DEVELOPMENT DETERMINATION PANEL MEETING

WEDNESDAY 22 JUNE 2022

3.1 DA2021/1824 - 23 Hay Street COLLAROY - Alterations and additions to a dwelling house including a swimming pool and cabana 5

Figure 1: *Location of recommended privacy shelf below windows W6 and W7 shown in red and the 45 degree angle of the Bahama Shutter Blade (shown in pink) showing that views from 1.7m and below will be restrict by the location of the privacy shelf*

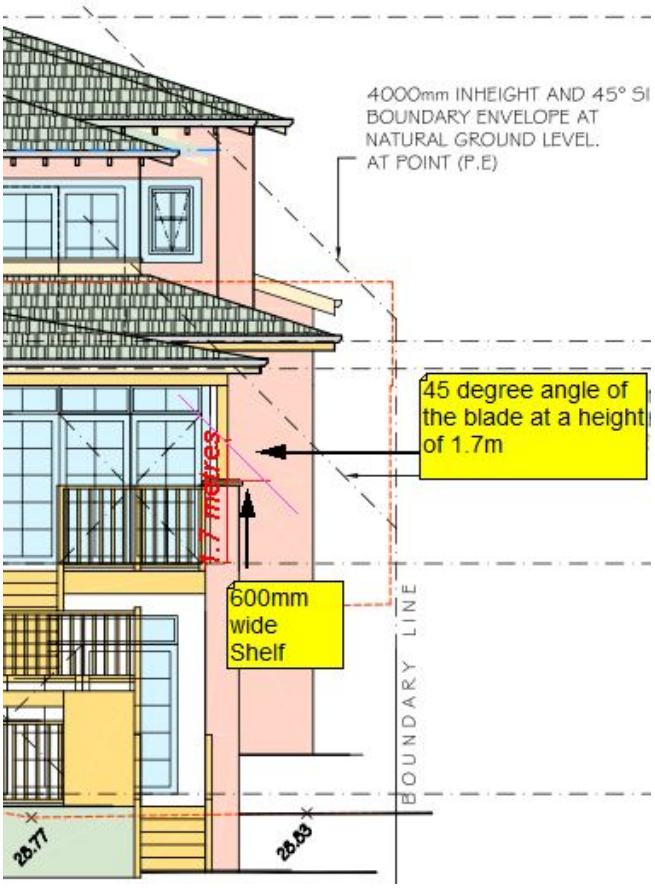
A condition is recommended requiring the Bahama Shutters to have a 45 degree angle facing downwards and that a 600mm wide shelf below windows W6 and W7 be installed. The standard requirement for privacy screening is to have a minimum height of 1.7m, which is below standard eye level when standing and below sitting height. The 45 degree angle of the blades of the Bahama Shutters, along with the 600mm wide shelf will restrict views from the northern elevation windows W6 and W7 of the private open space of the adjoining property at No. 25 Hay Street from a height of 1.7m from Finished Floor Level (FFL). Figure 1 below shows the recommended privacy shelf in red and the 45 degree angle of the Bahama Shutter Blades (shown in pink) which will restrict views from the windows W6 and W7 of the private open space of No. 25 Hay Street.

Figure 2 *: Section through proposed development showing building height non-compliance. Councils extrapolated ground level shown in pink and the applicants shown in dashed blue line*

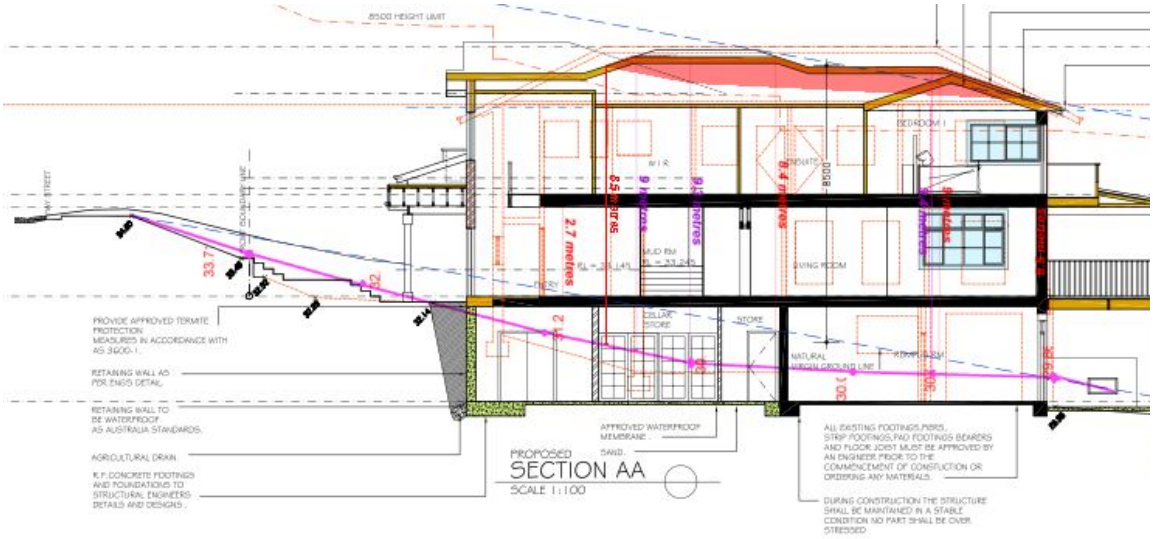
The site has been heavily disturbed and the lower level of the dwelling excavated. In determining the height of the proposal, relevant caselaw in the Land and Environment Court, including the case *Bettar V Council of the City of Sydney* [2014] NSWLEC 1070 and *Stamford Property Services Pty Ltd V City of Sydney & Anor* [2015] NSWLEC 1189 has been applied in that the measure of building height should relate to the levels and natural topography of the site, and not relate to artificially modified levels such as those made through excavation or landfill. Therefore, for the purpose of this assessment, the applicant has provided 'natural' ground levels to determine the height of the building extrapolated from survey points around the perimeter of the site. The assessment officer has also determined their own extrapolated ground level based on contour points and surveyors from adjoining properties. For the assessment of this application, the assessment officer will be using their own extrapolated natural ground level, as it shows the possible worse case scenario in regards to building height.

Figure *5:* *North elevation side boundary envelope non-compliance from the survey levels*

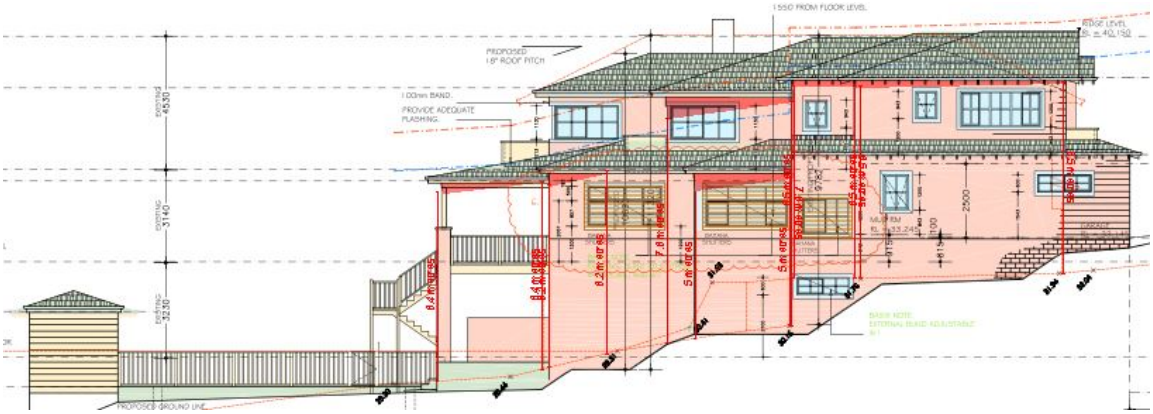
Figure 5 shows the northern side boundary envelope encroachment from the levels taken off the driveway survey points and Image 6. shows the side envelope encroachment with a extrapolated ground line taken from the survey points on road reserve and from the middle of the site. Both measures show what the side boundary envelope encroachment will be with Bedroom 3 and ensuite conditioned to be setback 2.5m from the northern boundary.

The proposed development encroaches into the northern elevation on both the Ground and First Floor levels. The southern elevation will maintain the existing side boundary envelope non-compliance.

Figure 7*: Front setback non-compliance*

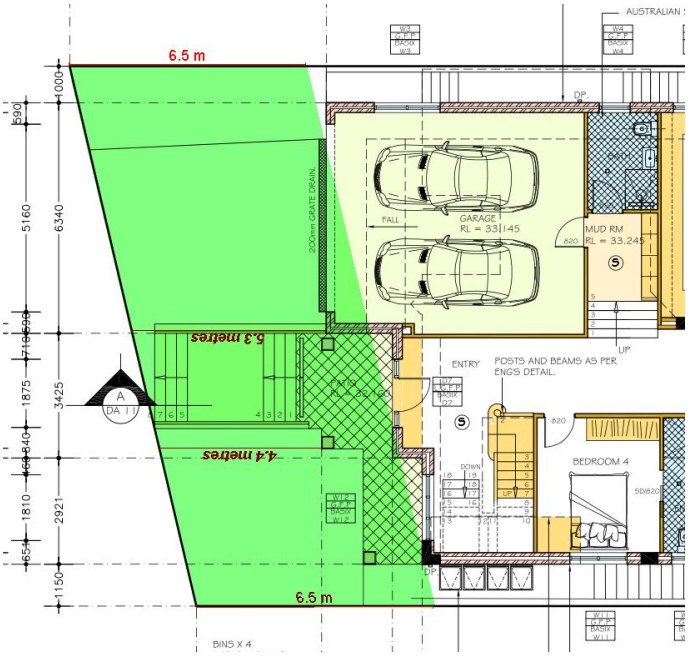
Description of Non-compliance
The proposed front patio and a portion of the Double Garage encroach into the front boundary setback area. The patio has a minimum setback of 4.4m and the double garage 5.3m. Figure 7 below shows the front setback area marked in green. The first floor of the dwelling is outside of the front setback area and complies with the requirement.

The control requires development to be setback 6.5m from the front boundary.

Figure 8*: Rear setback non-compliance*

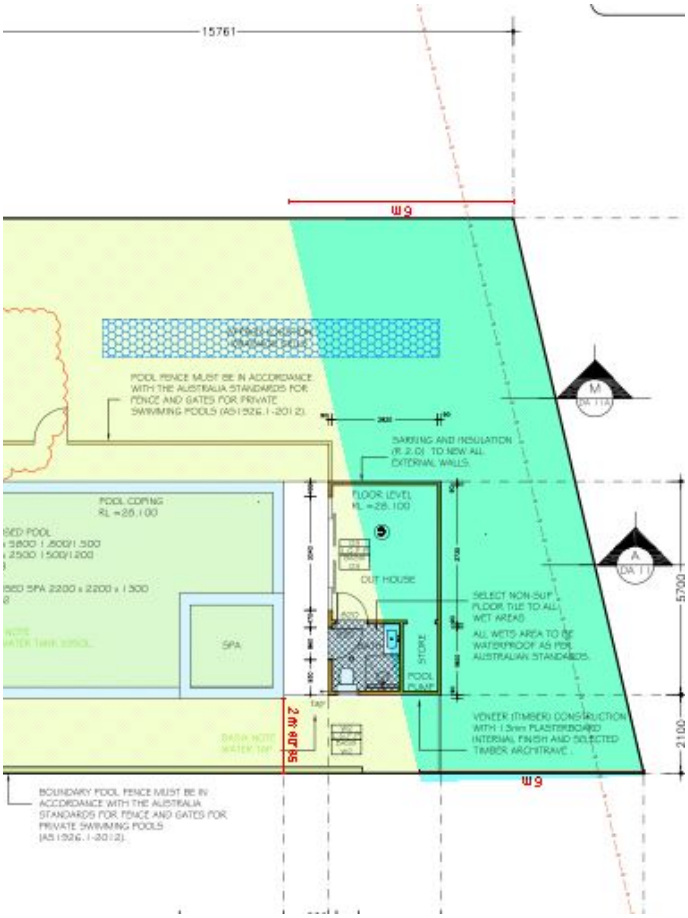
Description of Non-compliance
The proposed swimming pool and cabana are situated 3.489m from the rear boundary, representing a non-compliance with the minimum 6.0m rear setback control.

***Figure 1**: Side Building Envelope Encroachment - Western Elevation*

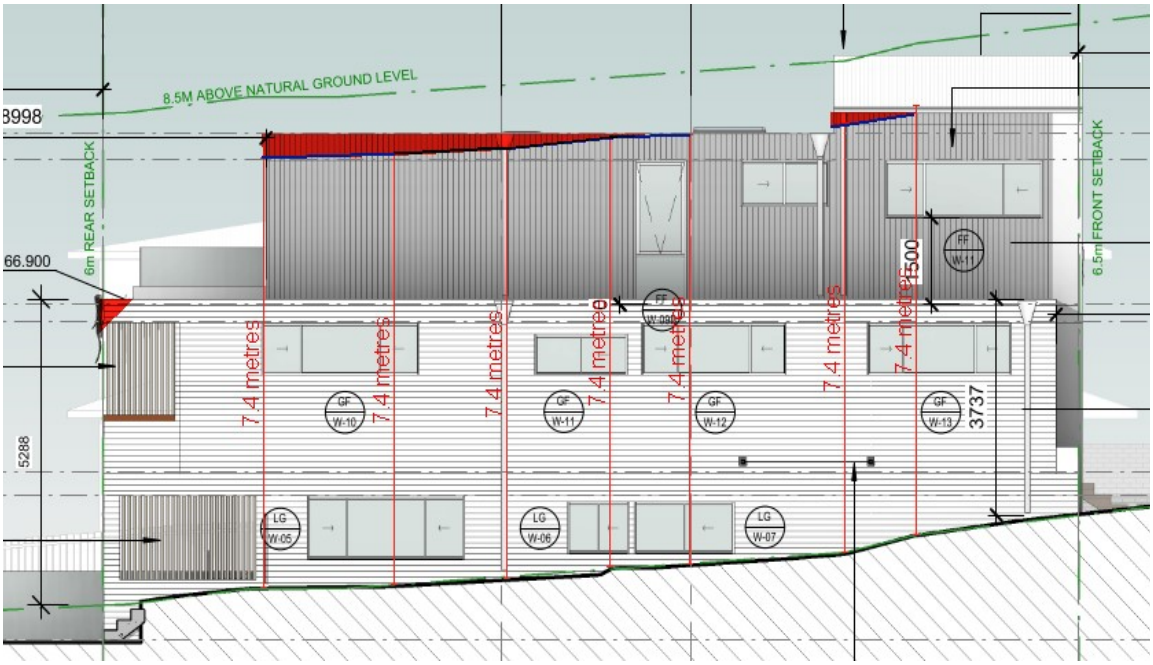
The proposed development encroaches the side building envelope on the western elevation, presenting a maximum variation of 46.3% (Figure 1).

Diagram 1: *Height Pole Locations Aerial View - Red dots are the height poles, pink line is the new rear setback of first floor*

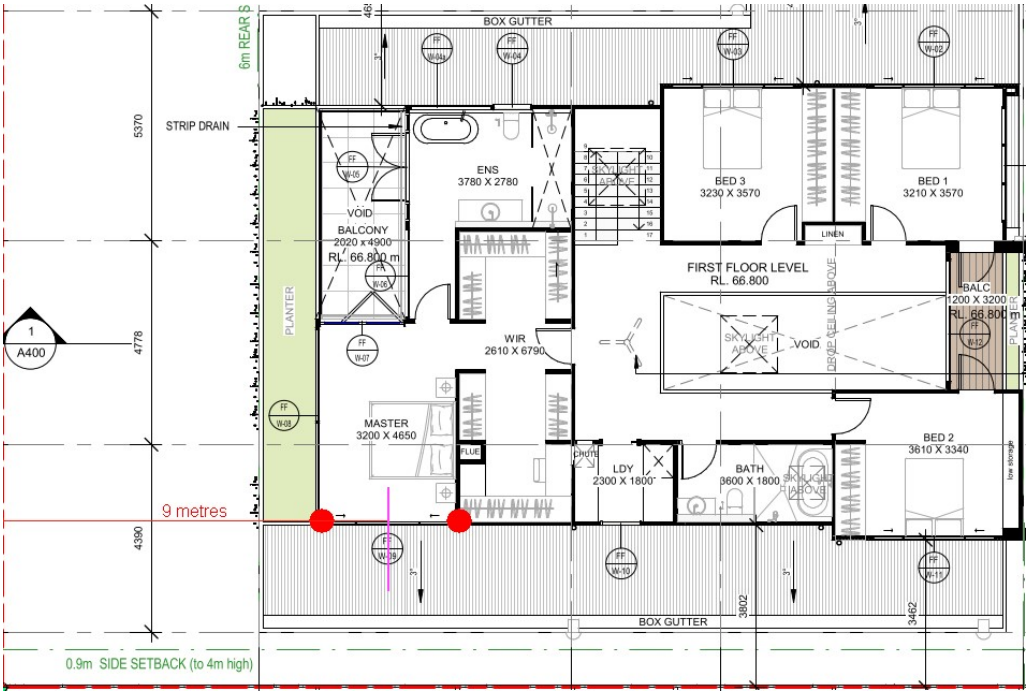
Therefore, the proposed dwelling house is considered reasonable in the circumstances of this application and demonstrates a reasonable sharing of views, particularly considering the views are across a side boundary.

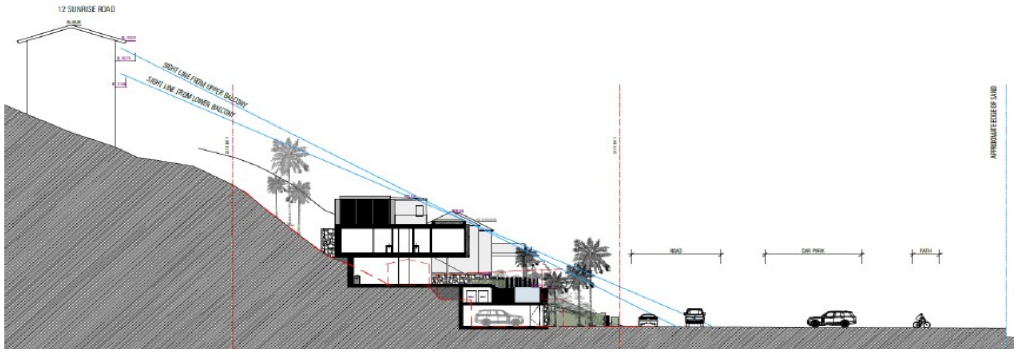
12 Sunrise Road
The applicant has submitted a View Analysis plan DA3(A) based on the available survey information which demonstrates that the proposed development will not obstruct the existing ocean views enjoyed from No. 12 Sunrise Road, refer to image below:
